Superfund Record of Decision: IBM (San Jose), CA
(EPA/ROD/R09-89/029)
December 1988

Superfund Record of Decision (EPA Region 9): IBM (International Business Machines), San Jose, CA (First Remedial Action), December 1988

SUBJECT: DRAFT REMEDIAL ACTION PLAN FOR INTERNATIONAL BUSINESS MACHINES, SAN JOSE FACILITY

FIGURE 5A - SAN JOSE WATER COMPANY AND PRIVATE WELLS IN THE UNDEFINED AREA

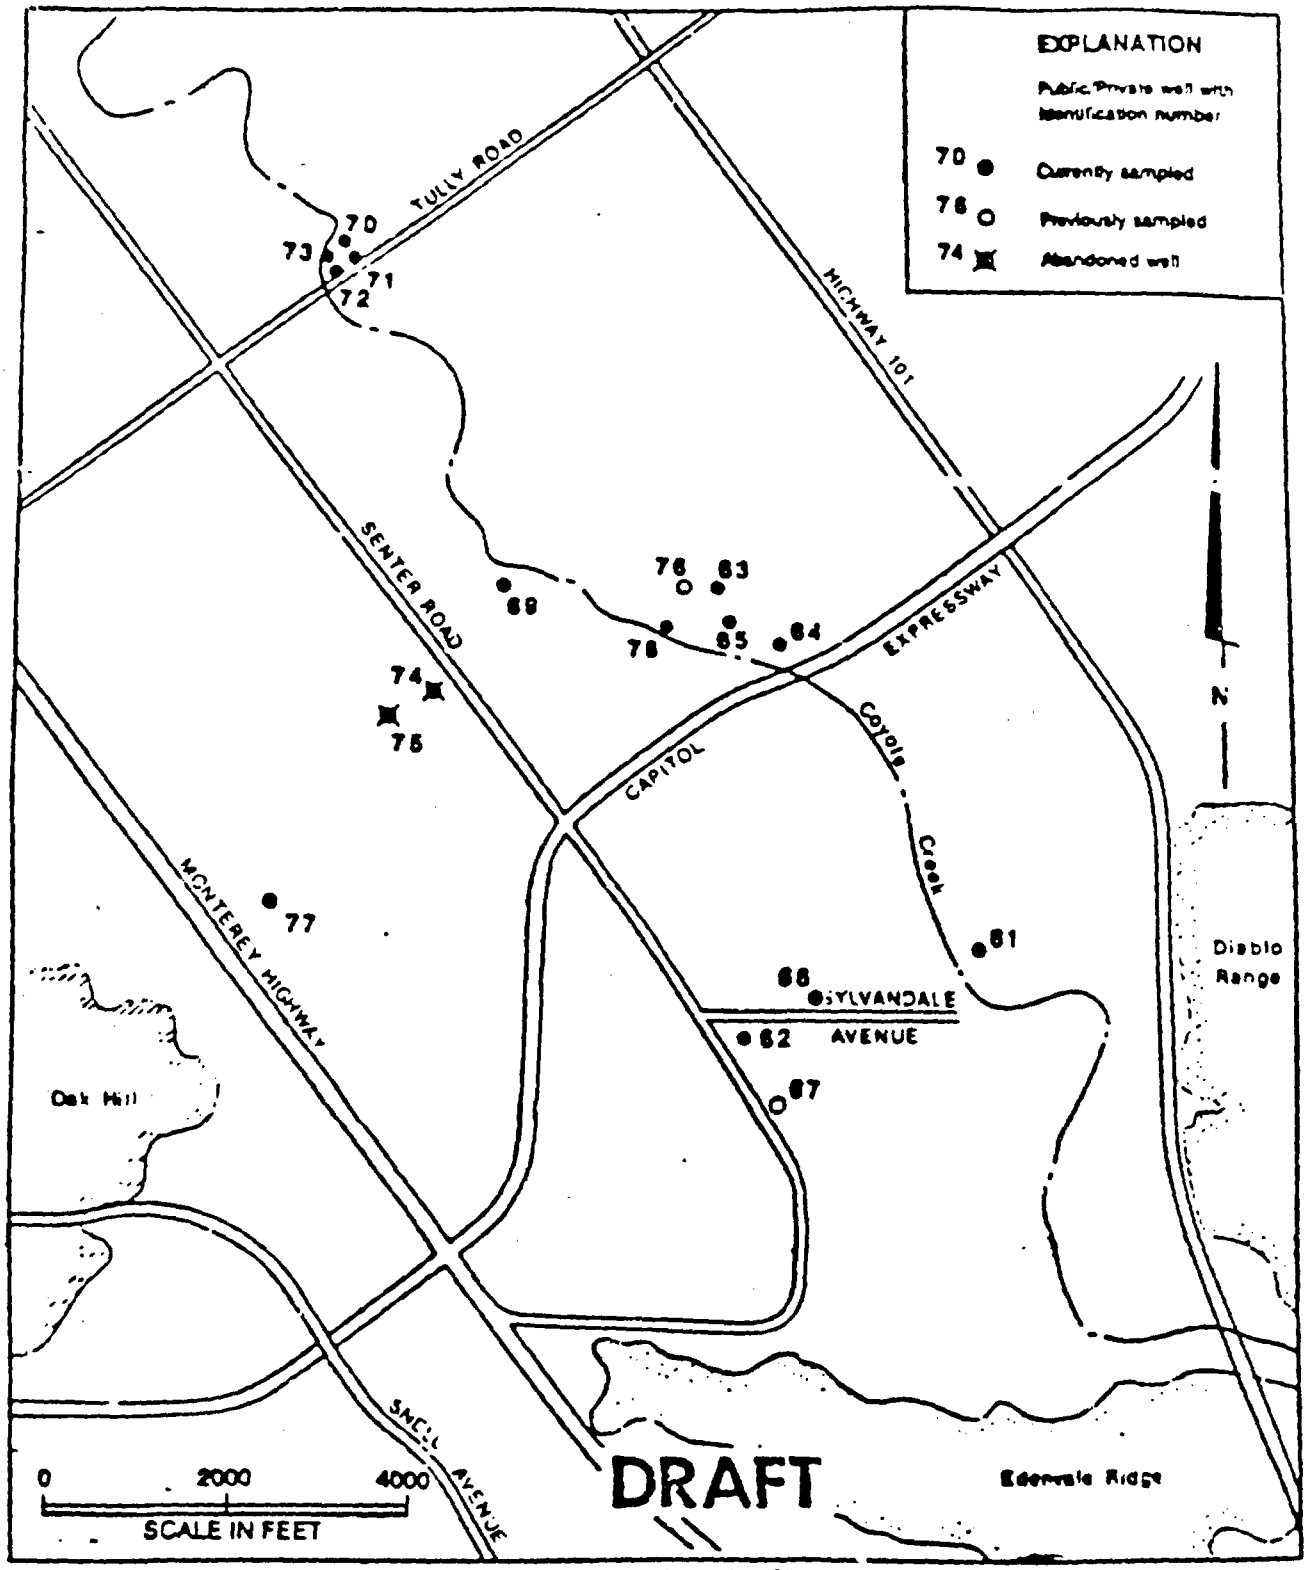
A third impact would be that low chemical concentrations will remain in the aquifer and affect water supply wells (Figure 5A). Chemical concentrations in the downgradient water supply wells, especially wells in the undefined area, may increase, although it is not expected. Even minimal increases should not impact beneficial uses and will still be protective of human health.

FIGURE 6 - PROPOSED RECHARGE AREA IN RELATION TO GREAT OAKS WATER WELLS

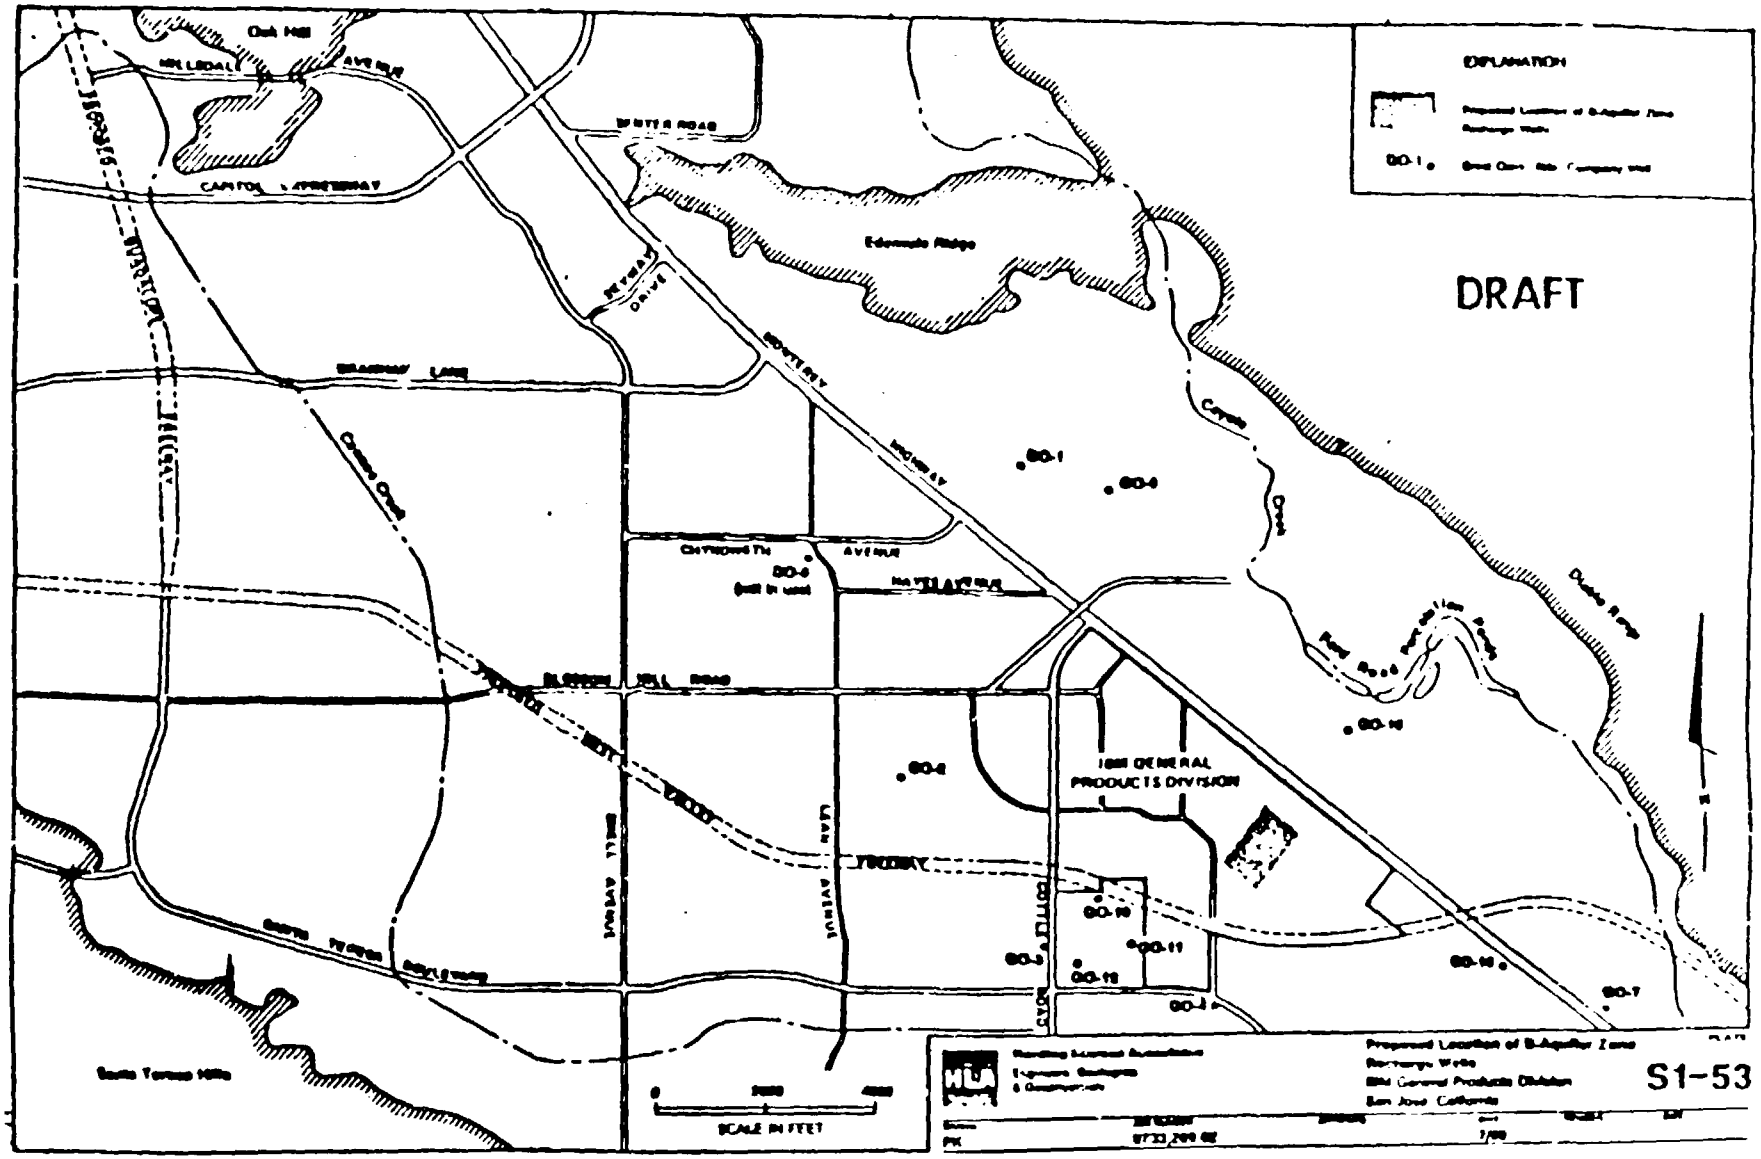
A fourth impact may result due to aquifer injection of treated groundwater. There is the potential that wells previously unaffected by the IBM pollution would be affected by the injected groundwater (Figure 6). The amount of water recharged may be limited to reduce this impact.

IBM IMPLEMENTATION SCHEDULE

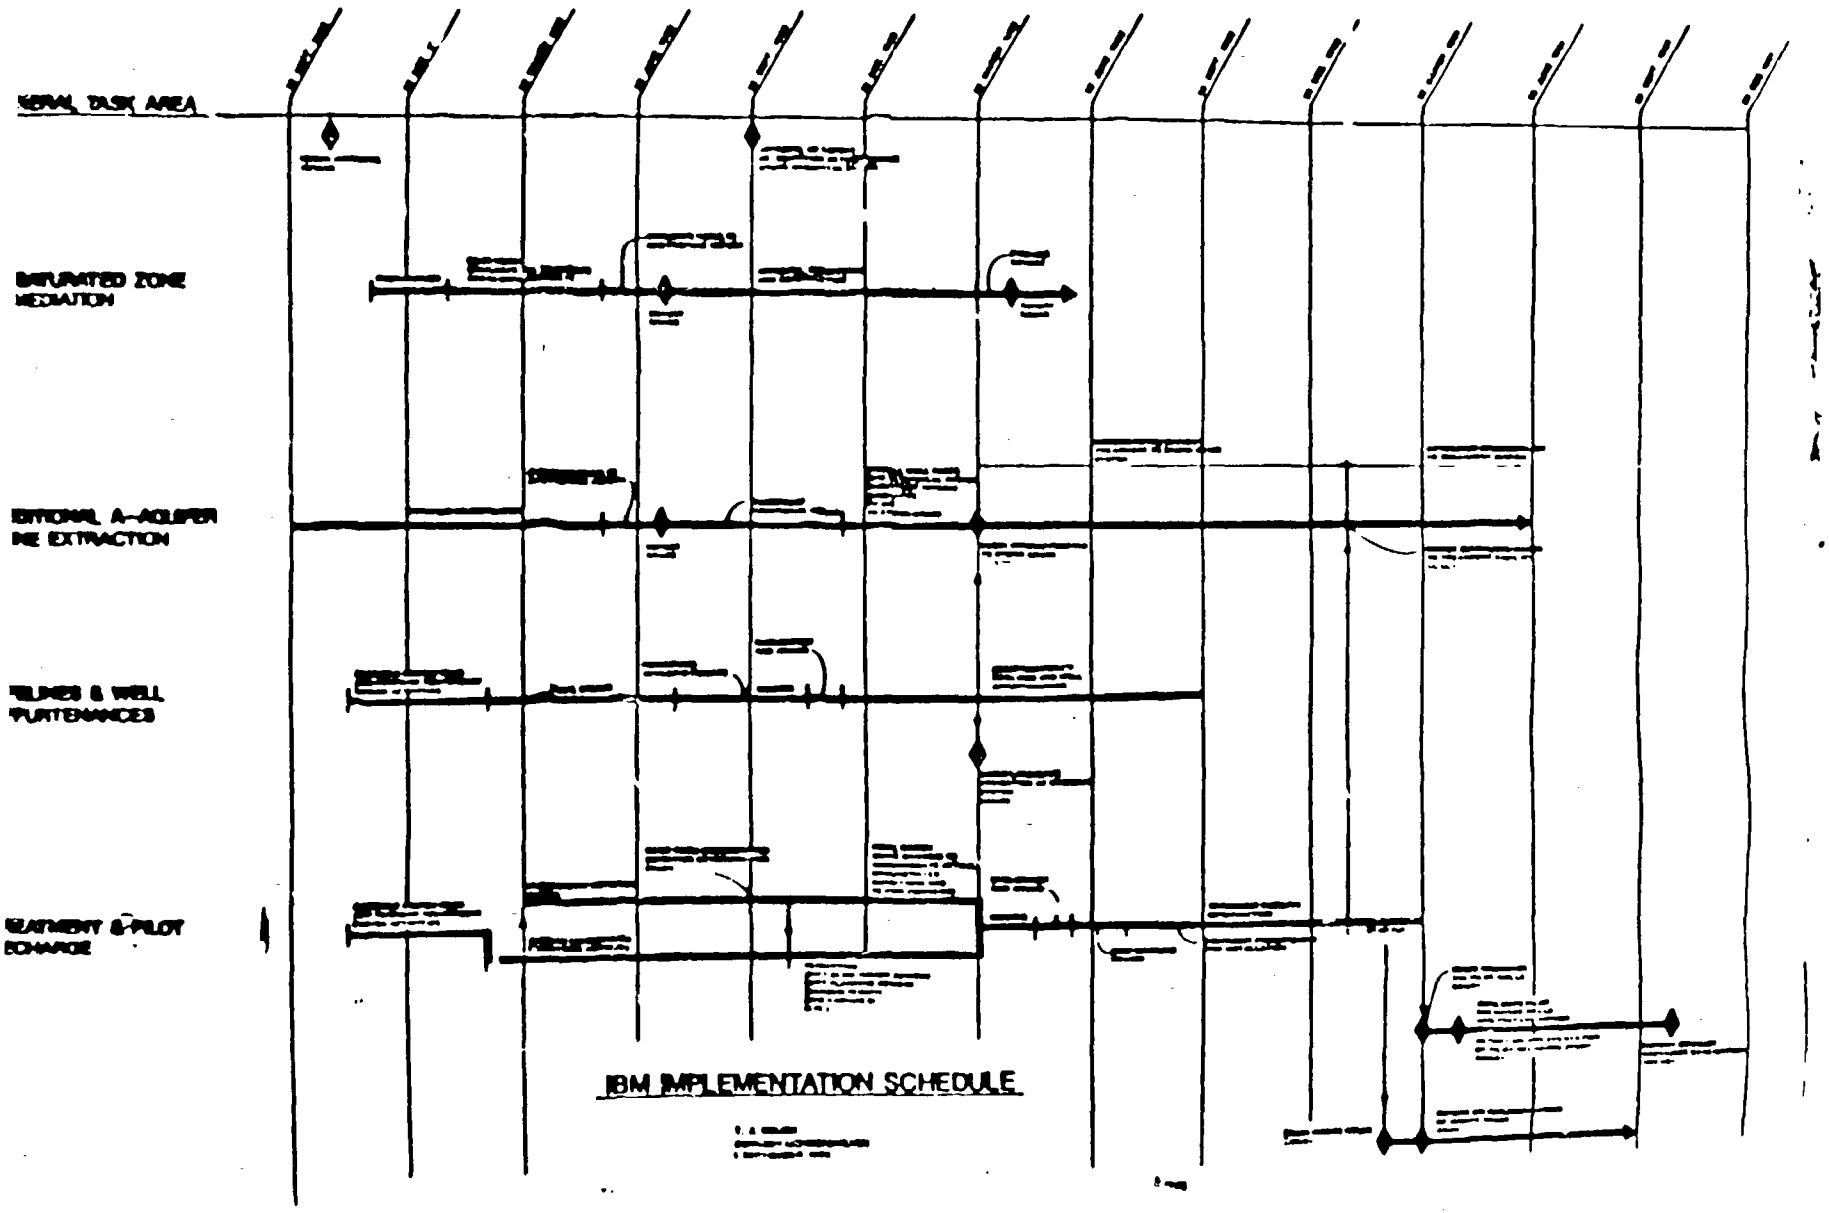
IBM submitted a proposed implementation schedule for the RAP or Contingency 2 remediation activities on Figure 8-7 of the draft Supplement dated April 1988. This figure presented IBM's projection of the timetable required for project implementation. However, the draft Tentative Order and draft NPDES Permit contain task submittal dates that represent significant reductions in the time available for implementation. IBM has concluded that the task schedule included in the draft Regional Board documents cannot reasonably be met given the

Attached is a figure summarizing the time required for major project elements. Time is shown to cover necessary investigations, preliminary and final design, agency reviews and approvals, permitting, construction, and startup.

In the event a permit is necessary, the 21 November 1988 due date for Task 1 appears to be premature for filing a complete Bay Area Air Quality Management District (BAAQMD) application. Relatively detailed plans and equipment specifications typically must accompany such an application. These items will not be completed by November 1988. IBM will initiate liaison with the BAAQMD by 21 November 1988 and will submit the required applications, as necessary, in a timely manner consistent with the attached project schedule.

The proposed completion date (20 February 1989) for Task 7 is also premature. By this date, there will not be sufficient additional information on which to base further definition of extraction well locations and parameters. The extraction well installation proposal should follow the groundwater condition decision analysis scheduled for completion 21 August 1989 (Task 12), after the plan to be implemented initially has been determined.
